Eastowne Medical Office Building (MOB)

May 23, 2018 Town of Chapel Hill Town Council

Site Plan Modifications in response to CDC, Council, and Staff Review

Eastowne MOB I and Eastowne Master Planning

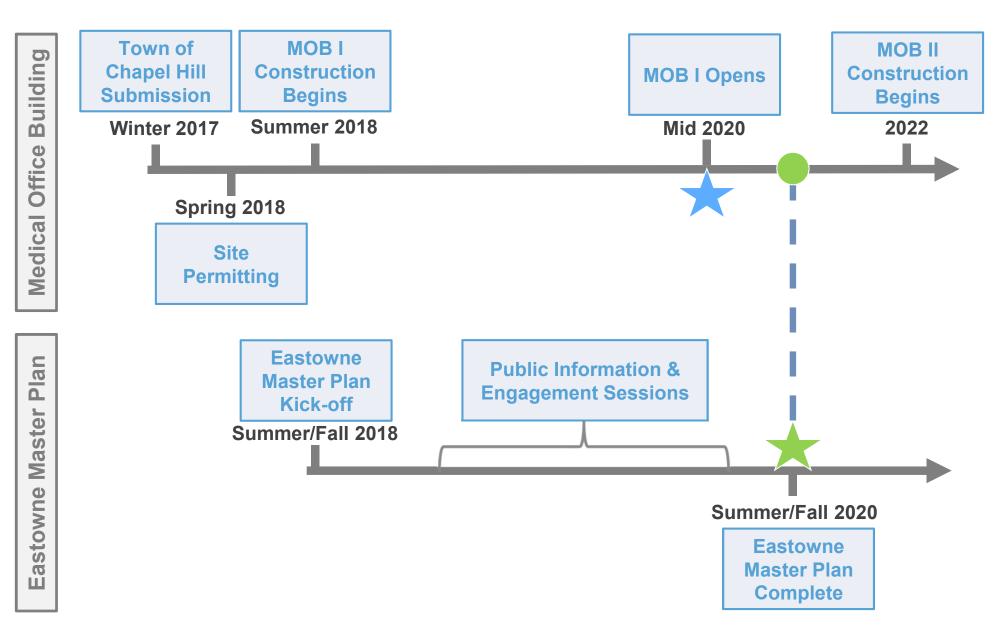
"Difficult to evaluate without context such as Master Plan"

Site Connectivity

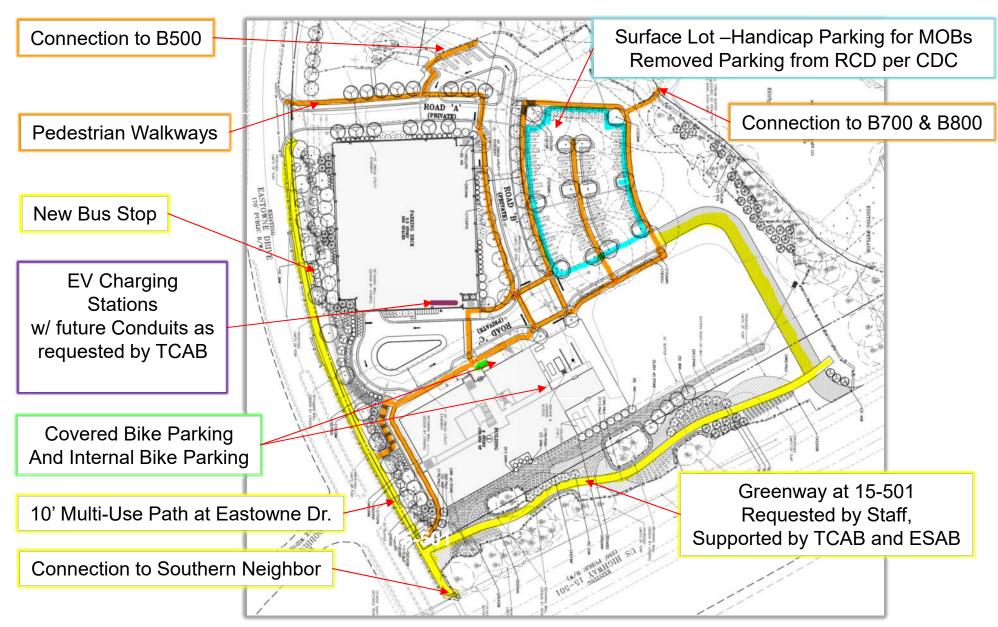
"How does this project connect with the rest of Eastowne?"
